DRAFT Preliminary Review: Navy Groundwater Flow Model for the Navy Red Hill Facility

The Department of Health Hawaii (DOH)

February 12, 2021

GW Elevation Variance – Transient Models

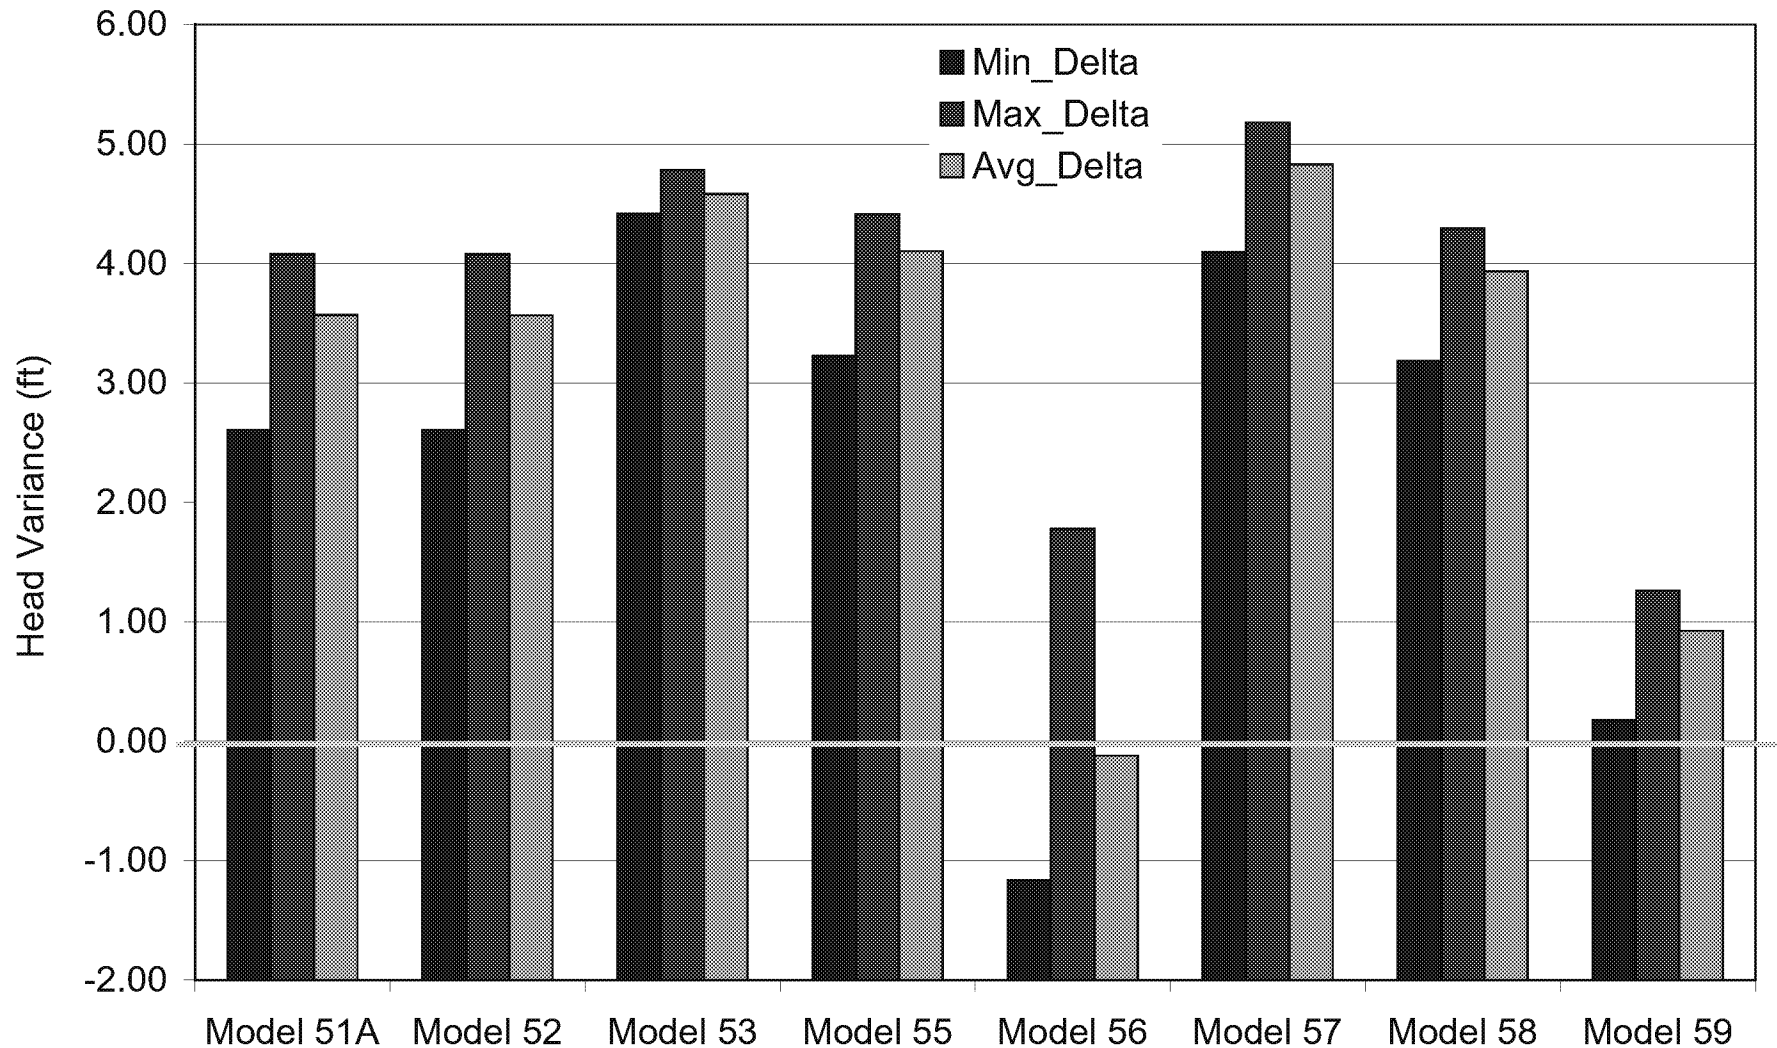
Modeled Groundwater Elevations Compared to Actual Synoptic Data
Verification Model Variances to Measured Red Hill Area Well

Modeled Gradients Are Too Large

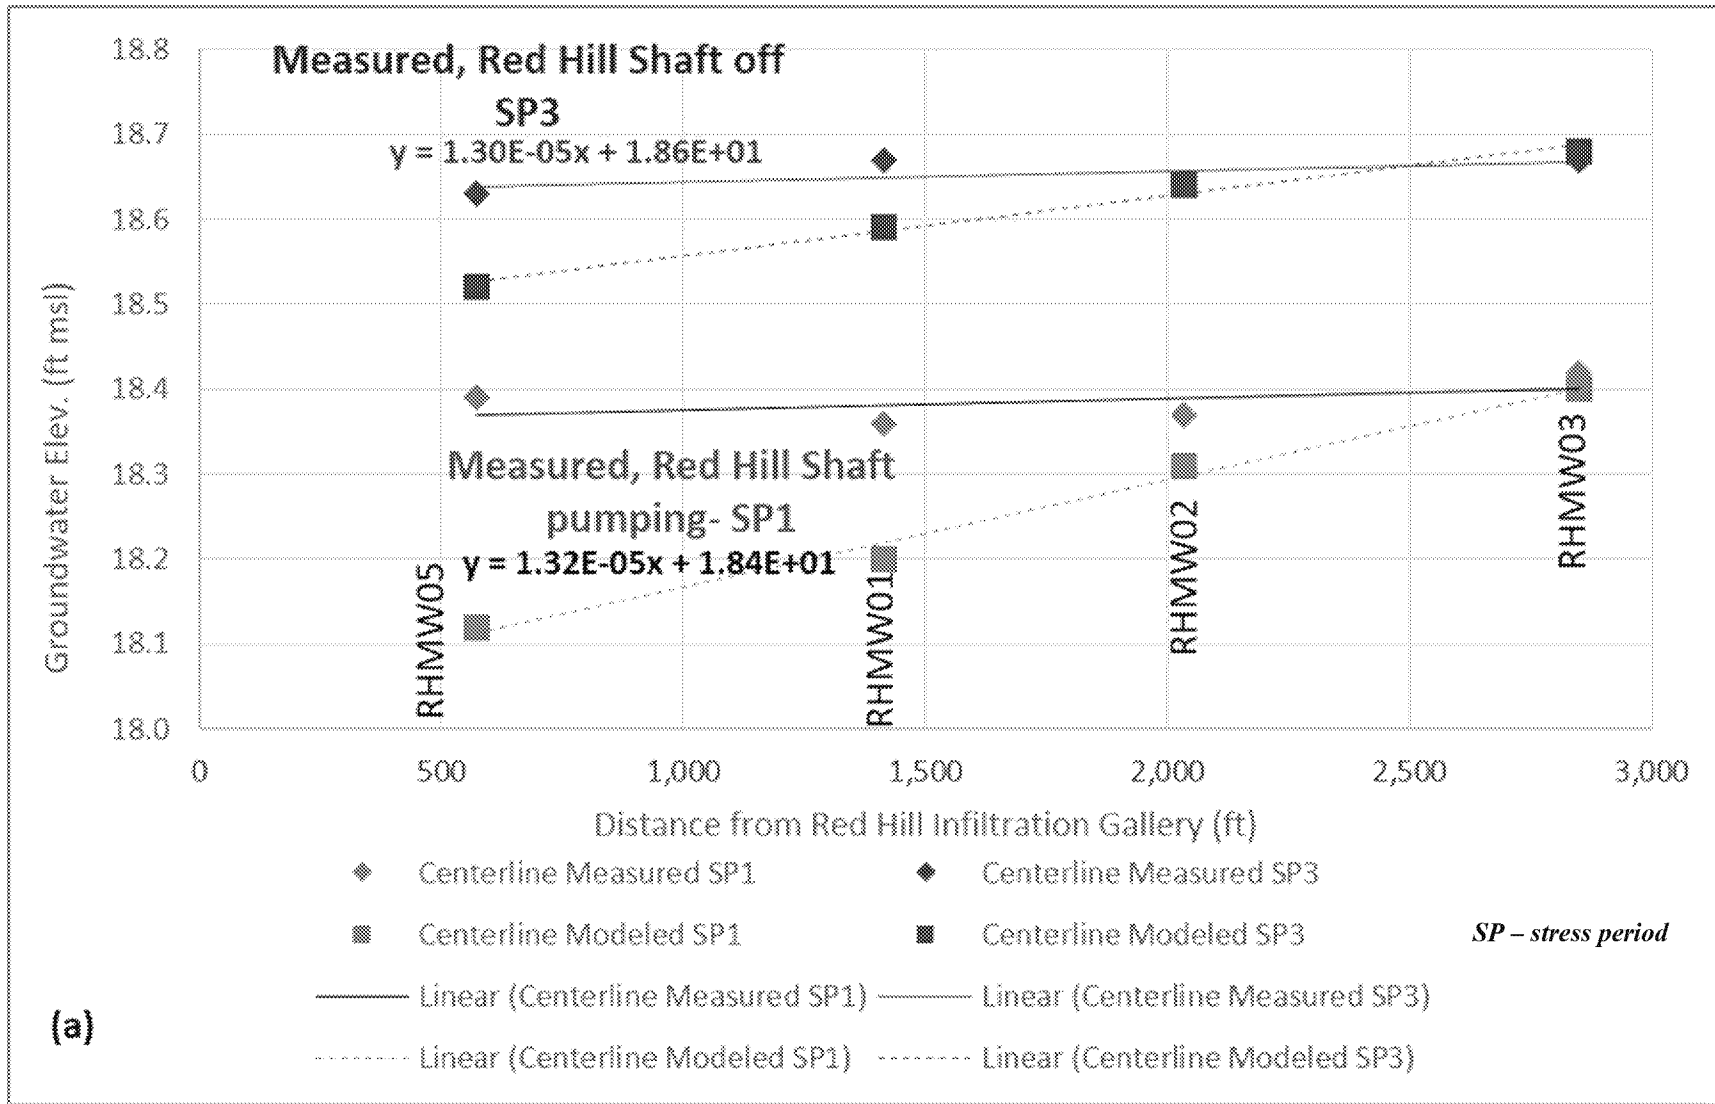
(Red Hill area, no gradient change under pumping)
